SUBJECT: REVIEW OF BWIP DOCUMENTS: SD-BWI-TI-226 AND
RHO-BW-CR-150 P

WMGT DOCUMENT REVIEW SHEET

ROCKWELL HANFORD #: SD-BWI-TI-226

TITLE: RHO-BW-CR-150 P - "PORFLO - A Continuum Model for Fluid Flow, Heat Transfer, and Mass Transport in Porous Media"

US DEPARTMENT OF ARMY
ENGINEERING CENTER
CORPUS CHRISTI, TEXAS
AS BUL 1
TYPICAL PIEZOMETER
SCHEMATIC
1964

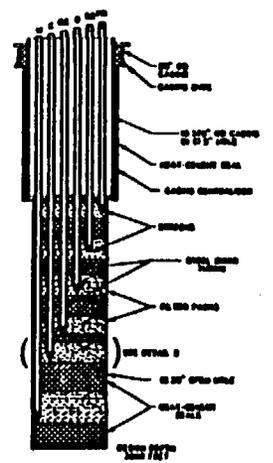
The report describes the process used by Rockwell Hanford Operations to select the locations for the cluster wells. The stratigraphic setting and general hydrogeologic background of the area is described in the report. Locations for the three cluster sites are noted on the attached figure derived from the report. A design "as built" drawing for the A, B, C, and D series piezometers also is attached to this review.

located approximately two feet above the piezometer screen. The piezometer screens consist of continuous slot wire wound screen jacket over a perforated pipe base. The screens were surrounded by a filter pack consisting of two different types of gravel pack. The size distribution for the gravel packs is presented in the report under review.

The piezometers and wells were sealed using two methods, bentonite or Portland neat cement. Bentonite was used solely in the uppermost seals at the A series sites. The Portland neat cement was used at all other sites. American Petroleum Institute (API) Class A or B cements were the basic cements. Calcium chloride (CaCl) was added to the Class B cement on several occasions to accelerate the setting of the cement. Cellophane flakes were added to control slurry loss during cementing operations of "seal 6 at DC-20C" (p. 63). We believe that "seal 6" is opposite the Roza Member of the Wanapum Basalt.
